**Flood Control Project Maintenance  
Levee Inspections**

**Fall 2010 Levee Maintenance Deficiency Summary Report**

**Reclamation District No. 1602 Del Puerto**

**Levee Inspection Report By Mile - Fall 2010**

Levee Mile Report Line	15
Start Levee Mile	1.02
End Levee Mile	1.02
Location	Water Side
Category	Interior Drainage & Piping Systems
Item	Encroachments

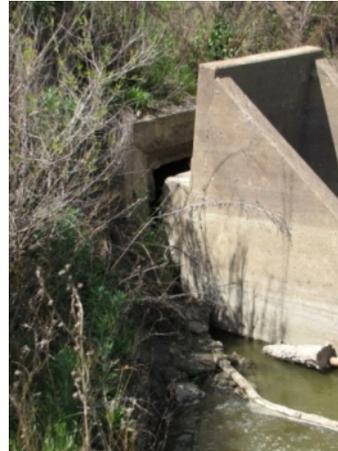
PVC pipe connected to steel pipe on landward toe at LM 1.02
